The Commission has issued the enclosed Amendment No. 91 to Facility License No. DPR-33 for the Browns Ferry Nuclear Plant, Unit 1. This amendment changes the Technical Specifications in partial response to your application of July 13, 1983 (TVA BFNP TS 190), as supplemented by your submittal of July 21, 1983.

The amendment revises the Technical Specifications to incorporate the limiting conditions for operation during Cycle 6.

AMENDMENT TO FACILITY OPERATING LICENSE

Amendment No. 91  
License No. DPR-33

Figure 3.5.K-1

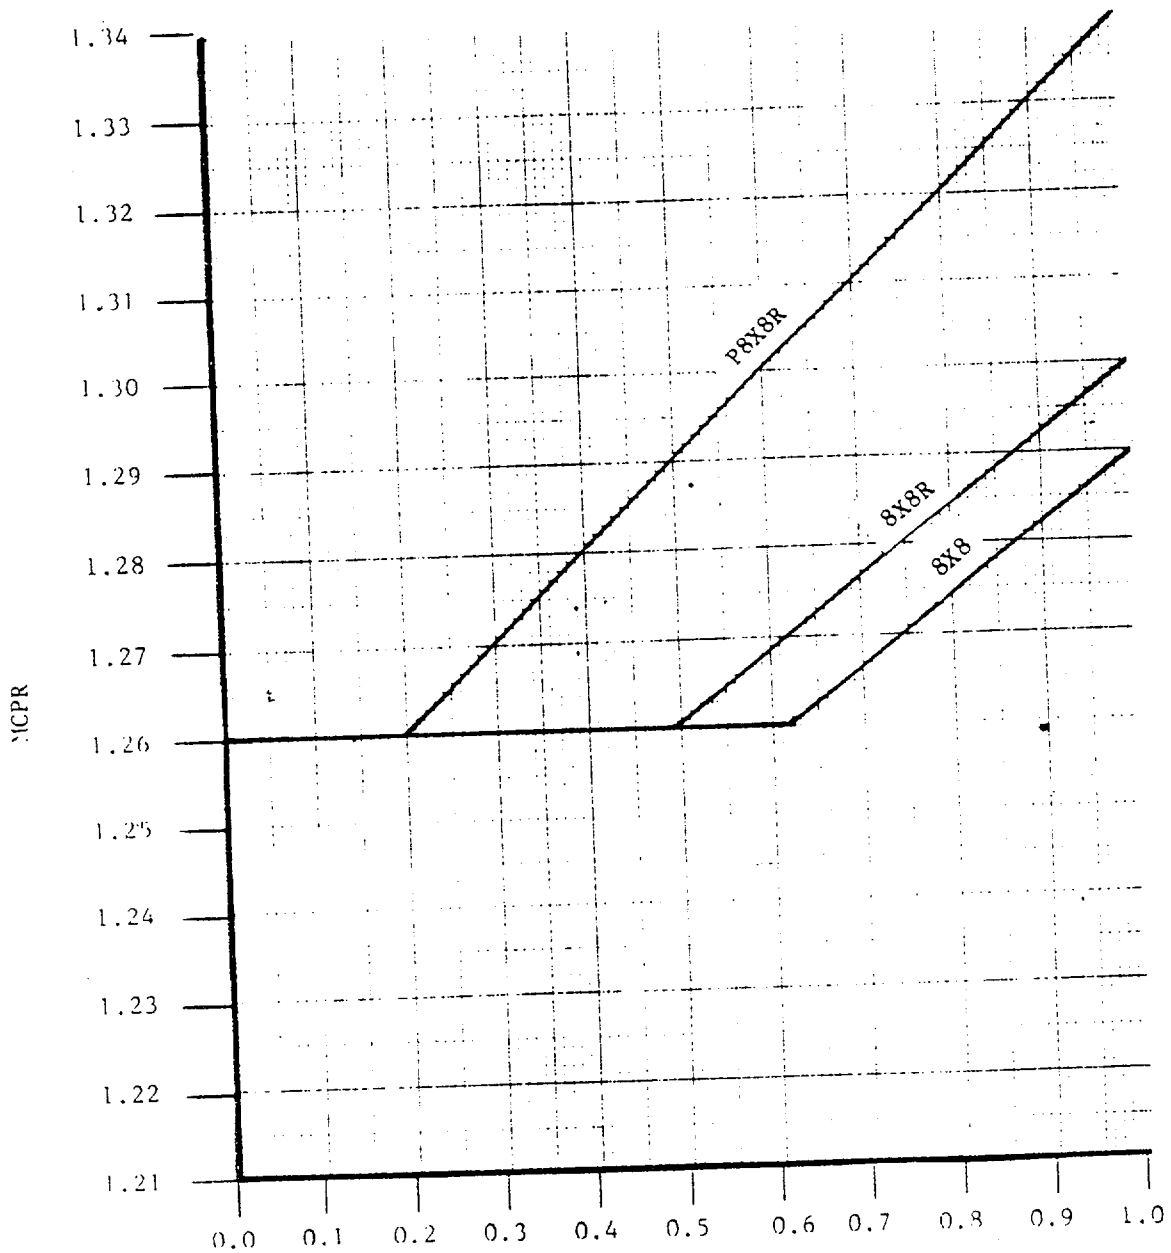
The operating limit MCPR values are being altered to conform to the results of the safety analysis for Cycle 6 and are acceptable. Additional MAPLHGR curves for the new fuel being inserted for this cycle are included. These are acceptable changes.
